Docket Item #4
Development Site Plan #2023-00012 550
South Pickett Street
Avanti 550 Retail Building

Purpose of Application
The applicant requests approval of a Development Site Plan with modifications to construct a new retail building.
Applications/Special Use Permits/Modifications Requested:
Development Site Plan to construct a new retail building with a modification of the 50-foot setback from the centerline of South Pickett Street.

Staff Recommendation: APPROVAL WITH CONDITIONS
Staff Reviewers: Robert M. Kerns, AICP, Division Chief robert.kerns@alexandriava.gov Nathan Randall, Principal Planner nathan.randall@alexandriava.gov Leon Vignes, AICP, Urban Planner bert.vignes@alexandriava.gov

SHEET 6 OF 13

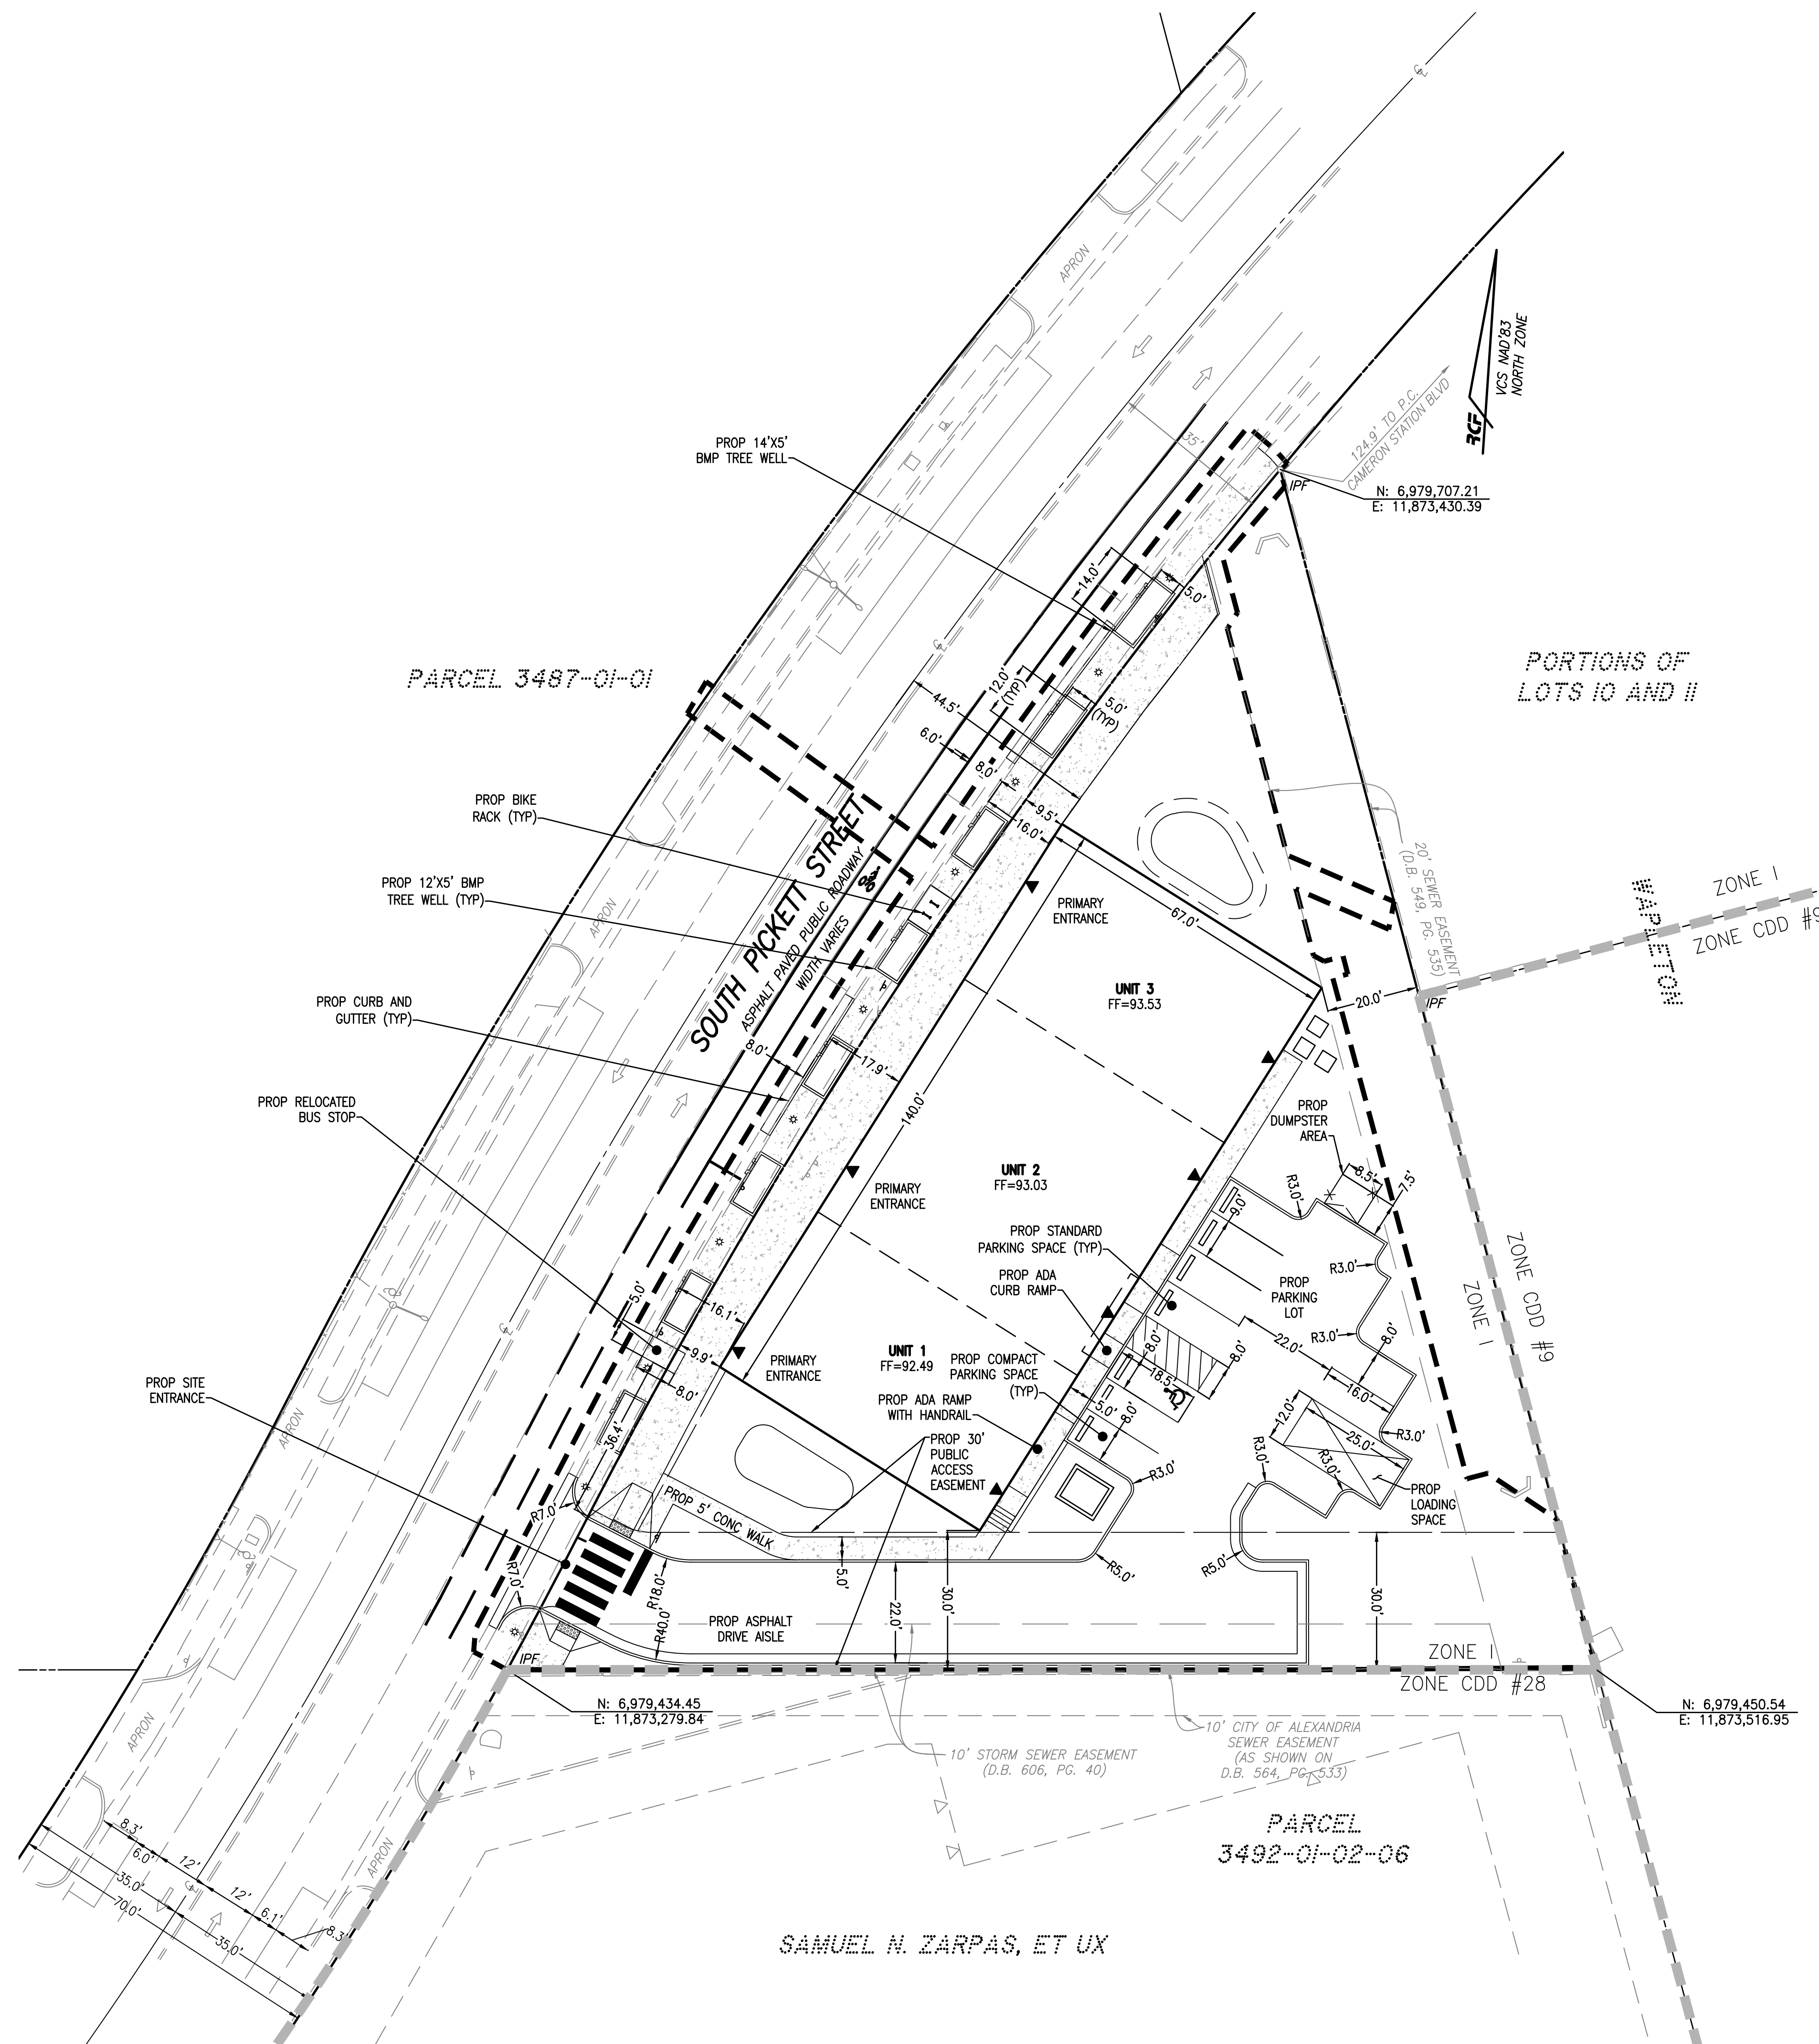
- b. Add to Sheets 5 and 6 the same kind of zone change line and labeling between 550 South Pickett and the property to the south as is shown between 550 South Pickett and the property to the east – except that the property to the south is zoned CDD#28.

Response: The zone change lines have been updated to accurately reflect the current zones of the adjacent property. Please see sheets 4, 5, and 6.
